**Subject: MHI's Responses to US-APWR DCD RAI No.750-5675 Revision 2 (SRP 19)**

Responses to Request for Additional Information No.750-5675  
Revision 2

**US-APWR Design Certification**

**RAI NO.:** NO. 750-5675 REVISION 2  
**SRP SECTION:** 19 – Probabilistic Risk Assessment and Severe Accident Evaluation  
**APPLICATION SECTION:** 19  
**DATE OF RAI ISSUE:** 04/28/2011

Figure 19.507-1 Application process Flowchart (Ref. ASME/ANS RA-Sa-2009, Figure 1-3-1)

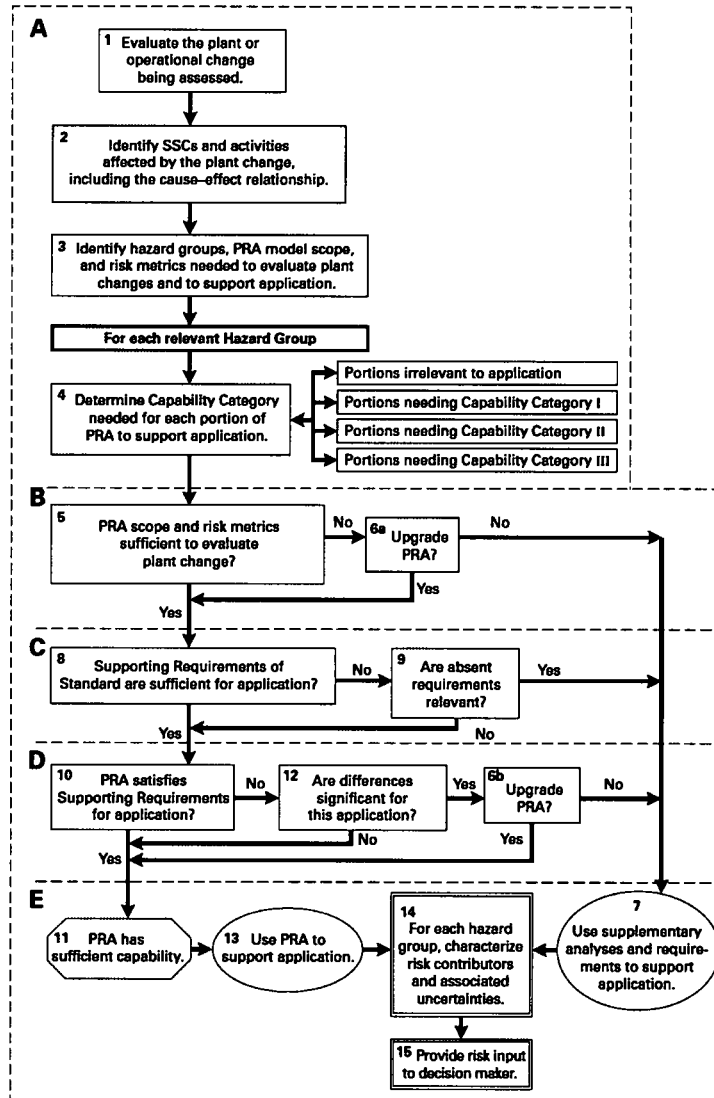
There is no COL action item in the DCD that addresses generically the issue of updating and upgrading the PRA to meet requirements needed for its intended uses and applications. Instead, a COL action item (COL 19.3(1) in DCD) is identified in the DCD which is specific to risk-managed technical specifications and calls only for updates of the PRA but not upgrades. COL Action Item 19.3(1) must be revised to indicate that it is the responsibility of COL applicants and licensees, as applicable, to update and upgrade the PRA model as necessary to meet the requirements needed for its intended uses and applications and as new or more detailed information becomes available during each of the COL application, construction, and operation phases. Specifically, COL Action Item 19.3(1) must be revised to address the following:

- (d) COL licensees referencing the US-APWR design must develop a PRA maintenance and update program that is consistent with the PRA Standard ASME RA-S-2002 and associated addenda, RG 1.200, and the key elements listed in Section 19.1.2.4 of the DCD.

This DCD section also requires that changes to the PRA due to PRA maintenance and PRA upgrade will meet the risk assessment technical requirements of the NRC-endorsed PRA standards, ASME/ANS RA-S-2008 and its 2009 addendum (i.e., ASME/ANS RA-Sa-2009). These standards define, in part, the process for determining when an update or upgrade to the PRA is required (refer to Figure 19.507-1 below).

COL applicants referencing the US-APWR DCD are required to follow the PRA maintenance requirements specified in DCD Sections 19.0 and 19.1. No additional COL item is necessary.

**Figure 19.513-1 Variation of The Containment Pressure**

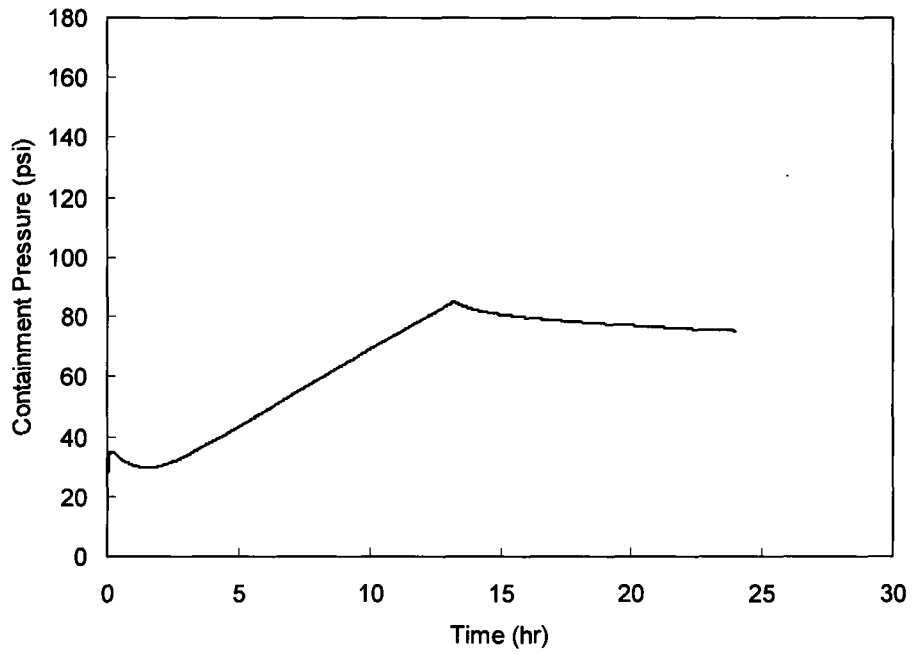
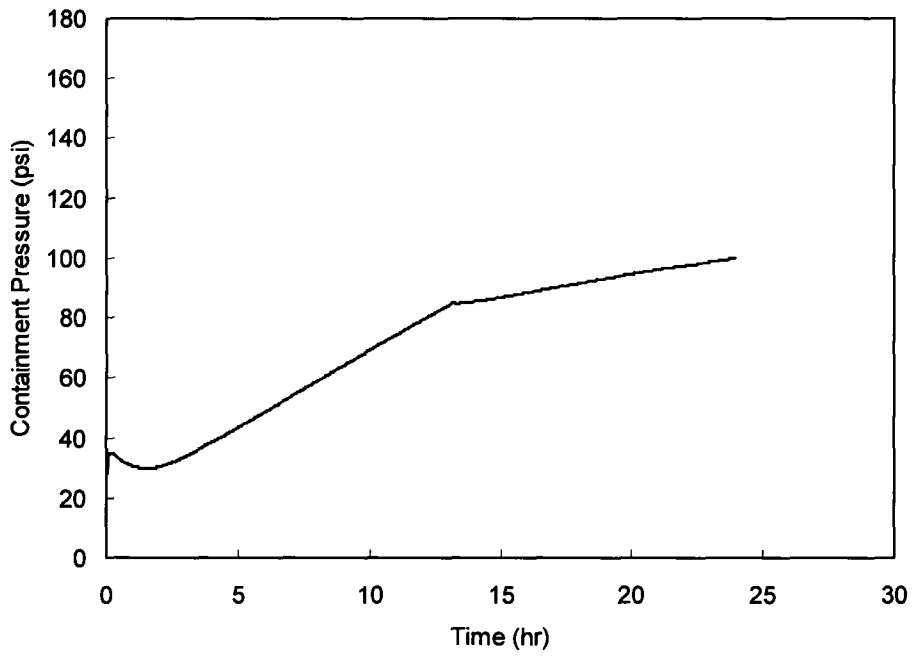
The staff requested additional information (RAI Questions 19-97, 19-98 and 19-364) regarding the implementation of the approach that was followed to determine PRA success criteria. In some cases, credit is taken in the T-H analysis of “bounding” sequences involving multiple failures for more than the minimum set of equipment that could be available based on the success criteria. In other cases, it is not clear whether some “success” sequences are bounded by an analyzed “success” sequence. In addition, there are no T-H analyses performed to support the assumed success criteria of some mitigating systems and functions, such as the alternate containment cooling function. Please perform a systematic investigation to demonstrate the robustness of the assumed PRA success criteria for all “success” sequences of significant frequency.

For alternate containment cooling by containment fan cooler units, the success criteria used in the PRA is one CCW pump and two containment fan cooler units. In order to provide the basis, MHI performed two MAAP analyses using calculation condition listed in Table 19.513-1. In Case 1 using two containment fan cooler units, although containment pressure rises after the initiating event, the pressure is decreased at approximately 13 hours due to heat removal via containment fan cooler units. On the other hand, containment pressure continues rising after initiating event in Case 2 using one containment fan cooler unit. The result shows that the one containment fan cooler unit will not remove heat in containment, resulting in failure of containment. For success criteria of CCW pump, since alternate containment cooling is effective mitigation system when heat removal via CS/RHR heat exchanger is unavailable, the CS/RHR heat exchanger with the highest heat load for CCWS is isolated by CCWS during alternate containment cooling by containment fan cooler units, which will not cause degradation of CCWS function nor cooling of other components. One containment fan cooler units requires water flow with approximately 100 m<sup>3</sup>/h. One CCW pump that has capacity of approximately

MHI will perform the T-H analyses to provide basis for the success criteria listed above by the end of this year and summarize the results in DCD Table 19.1-15.

**Figure 19.514-1 Variation of Leak Rate from RCS through Ruptured SG Tube**

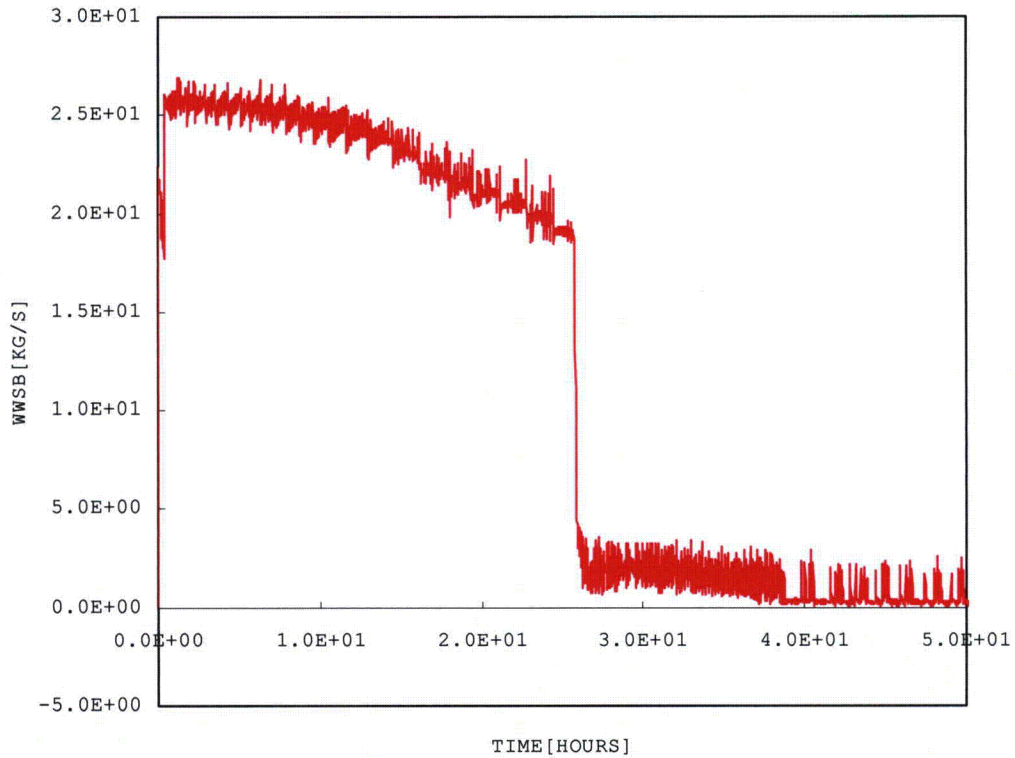
In RAI Question 19-108 the staff requested more information regarding the basis for not having modeled in SGTR sequences an operator action to depressurize the RCS in order to equalize primary and secondary pressures and stop the leak after the ruptured SG is isolated. MHI responded that this operator action was assumed to be always successful because the operator has plenty of time to perform such an action. The staff followed up with RAI Question 19-366 requesting more detailed justification. In response, MHI included a top event (event DEP) in the SGTR event tree, which represents operator failure to equalize primary and secondary pressures, without any quantification. The staff review finds that event DEP is highly risk significant (e.g., risk achievement worth (RAW) value is about  $4 \times 10^{+3}$ ) and it is not obvious without the benefit of a T-H analysis that its contribution to risk (e.g., as measured by the Fussell-Vesely risk importance measure) is insignificant. Furthermore, if a cutoff probability of  $1 \times 10^{-5}$  is used for DEP, the sequence CDF would be  $4 \times 10^{-8}$  per year, which is comparable to the CDF of some of the reported dominant accident sequences. For these reasons, the failure probability of DEP must be estimated and documented together with all key assumptions and bases (e.g., T-H analysis) used in the estimation. In addition, event DEP should be addressed in the accident sequence quantification and importance analysis.

T-H analysis was performed to estimate allowable time for equalization of primary and secondary pressure. Table 19.514-1 lists the analysis condition, and Figure 19.514-1 shows the variation of leak rate from primary system to secondary system via the ruptured SG tube. The total leak volume after 24 hours from SGTR event is approximately 71,000 ft<sup>3</sup> (2000 m<sup>3</sup>). As described in DCD Section 6.3.2.2.3, since RWSP has allowable water with more than 81,230 ft<sup>3</sup> [2300 m<sup>3</sup>], operators have more than 24 hours for the actions. It is assumed that it will take an operator less than one hour to identify SGTR via secondary side radiation detectors. The allowable time enables the dependency among the above four actions to be negligible.

**Figure 19.517-1 Decision Tree to Determine the Dependency Level between Multiple Human Failure Events (Same as DCD Figure 19.1-3)**

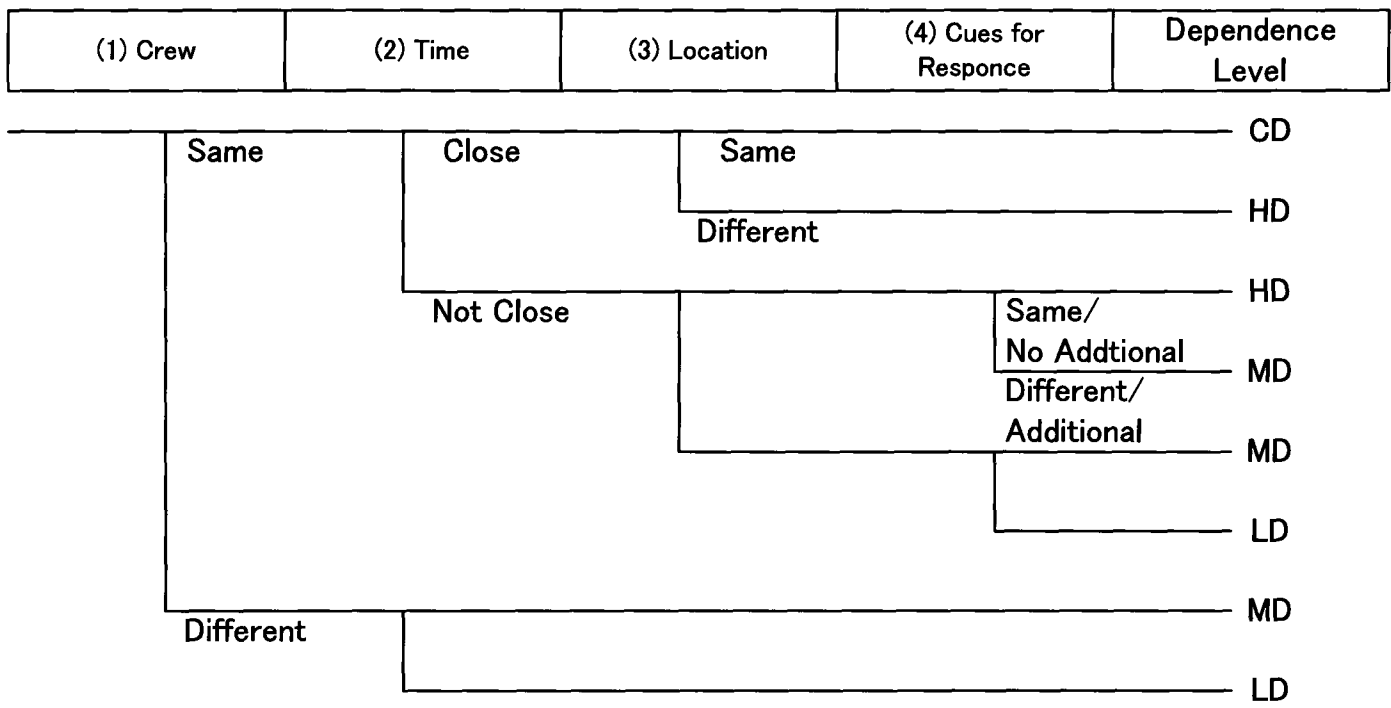
In RAI Questions 19-200 and 19-381, the staff requested clarification regarding the assumption of “different crews” made in evaluating the dependency level among human errors in SGTR sequences, such as the dependency among operator failure to close the MSIV associated with a faulted SG, the operator failure to isolate a faulted TBV and the operator failure to depressurize the primary using the SDVs. In its responses, MHI stated that “different” and “same” crews are defined based on the location where the operator action is performed. However, it appears that the same crew is performing the cognition aspects for all these actions from the control room and, therefore, the assumption of “different” crews is not valid. Please perform a systematic search of all significant accident sequences in the PRA to ensure that dependencies among operator errors are properly assessed.

For other human errors, dependency levels among the human errors are re-estimated using Table 9.4.3-1 of US-APWR PRA Report (MUAP-07030, Proprietary) and Figure 19.517-1. The table summarizes assumptions to estimate dependency level among human errors considered in the PRA. Dependency level among human errors is estimated by four factors, which are Crew, Time, Location and Cue. US-APWR PRA uses the following basis to estimate the factors.

NUREG/CR-6883 provides the basis to estimate the factor, which is from within seconds to a few minutes. Allowable time among operator actions considered in US-APWR is more than a few minutes. For example, operator actions for alternate charging pump cooling by fire protection water supply system (Basic Event ID: **ACWOO02FS**) or non-essential chilled water system (Basic Event ID: **ACWOO02CT**) has one hour since RCP seal integrity can be maintained for one hour with no seal injection. Operator action for alternate containment cooling by containment fan cooler units (Basic Event ID: **NCCOO02CCW**) has also sufficient allowable time with more than 10 hours. Assumption "Not close" is applied to all human actions in the US-APWR PRA.
